Review of Carbon TerraVault (CTV) Responses to EPA's Questions about the AoR Delineation Modeling Approach for the A1-A2 Class VI Project

In January 2022, EPA provided questions (*blue, italic text*) to CTV about the AoR modeling and modeling-relevant site characterization information in the permit application narrative and in the PISC and Site Closure Plan (Attachment E) submitted with CTV's Class VI permit application (dated August 30, 2021) for the proposed Carbon TerraVault (CTV)-Elk Hills Class VI geologic sequestration (GS) project. CTV provided an updated Area of Review and Corrective Action Plan and PISC and Site Closure Plan to EPA on March 31, 2022. EPA's evaluation of how the updated plans address its questions is presented in red below. Requests for revisions and additional information are presented in *red, bold, and italic* below. Previous responses that require no further information are not included in this enclosure.

Figure 4: Schematic section of the storage site with inputs to critical pressure calculation. Values for the USDW are based on the 326-7R well. The injection depth is based on the 357-7R injector. Using data from wells 357-7R injector and 326-7R the critical pressure is 3,400 PSI.

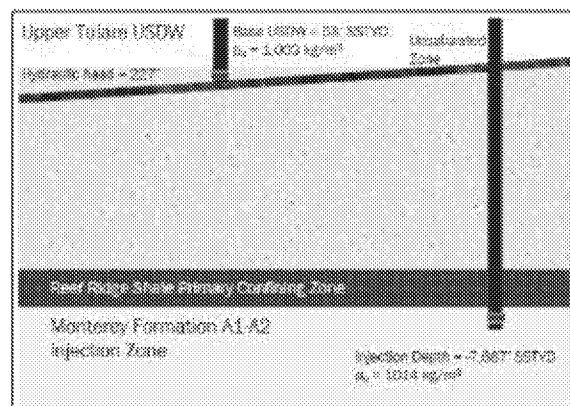
CTV submitted their critical pressure calculation to the GSDT in a file titled “Critical—Pressure—Calculation.PDF.” Using the inputs from Figure 4 and equation listed on pg. 3 of the Critical—Pressure—Calculation PDF, the critical pressure was calculated to be 3,400 psi. The final pressure of the Monterey Formation A1-A2 reservoir will be at or below the initial reservoir pressure of 4,000 psi, ensuring that post-injection conditions replicate those of initial conditions to the extent possible. Therefore, the AoR is based on the extent of the modeled CO₂ plume.

- *If any of the 152 wells in the AoR penetrate the entire Reef Ridge Shale, please explain how they are accounted for in the geomodel. No information was provided to address this question within the context of the geomodel.*

- *Please explain, in the context of the geomodel development, how any wells that penetrate the confining zone (and are potential conduits for fluid movement) are accounted for in the geomodel, or why it is appropriate to not include any of the wells that penetrate the confining zone in the AoR within the geomodel.*
